JORDAN

JORDAN REVISION LIST - STRUCTURAL:

JORDAN REVISION LIST - ARCHITECTURAL:

DATE: MARCH 15, 2019
REV.: MAY 01, 2020
DRAWN BY:
LNGINEERED BY:
REVIEWED BY:

A-6.1

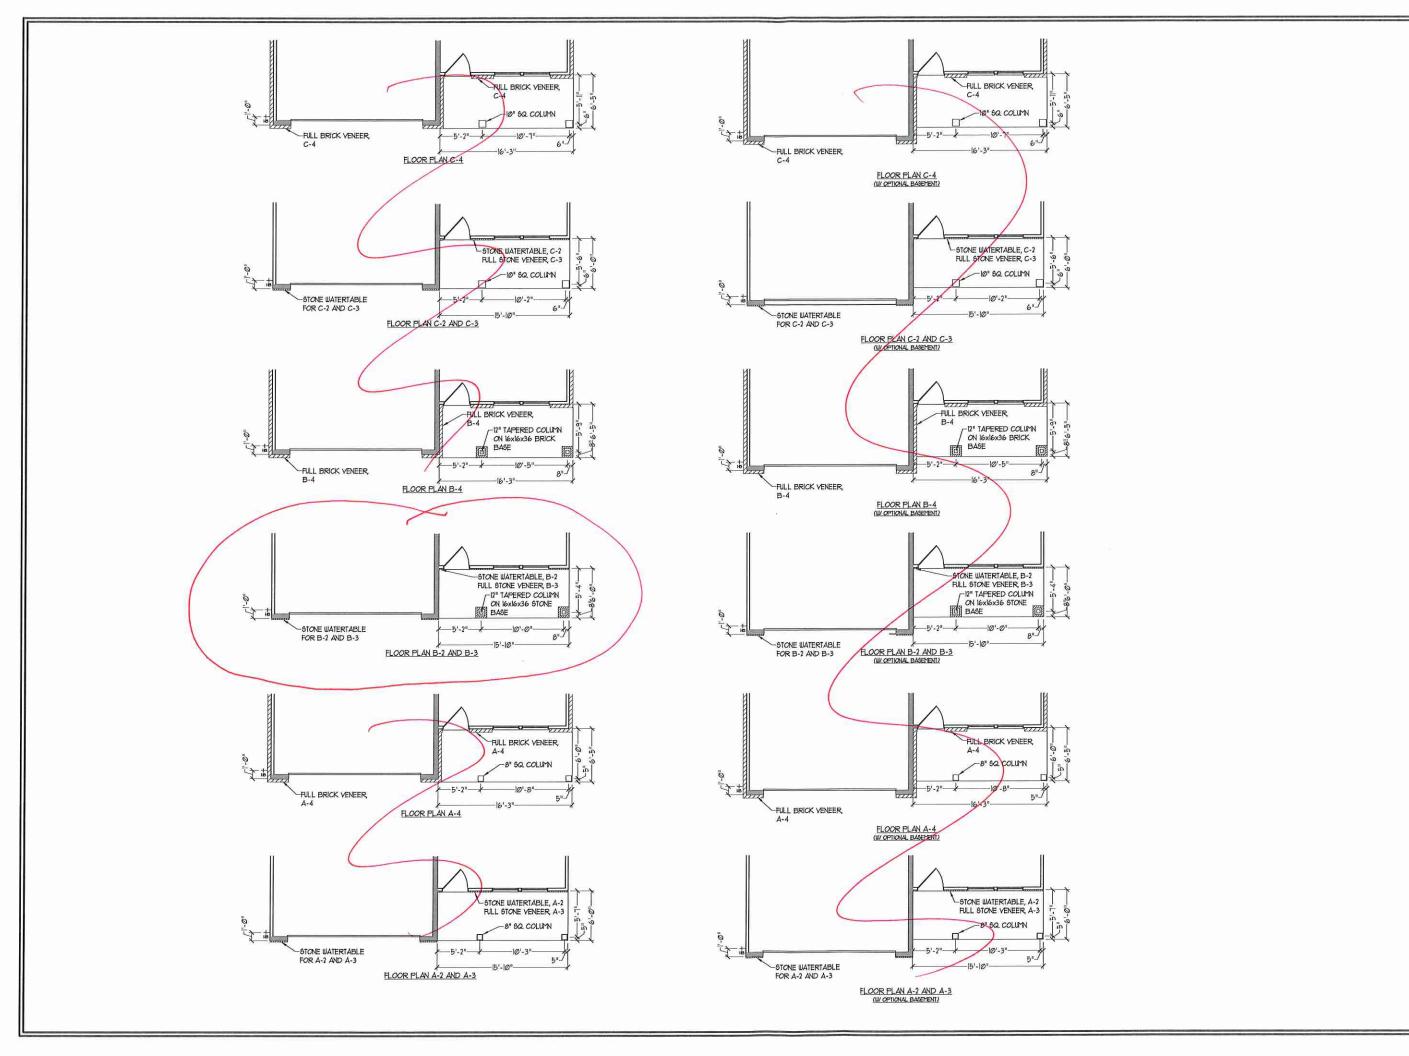
39.) CHANGED SWING OF SERVICE DOOR IN GARAGE TO OUT SWING (SEE SHEET A6.1) (7-8-20)
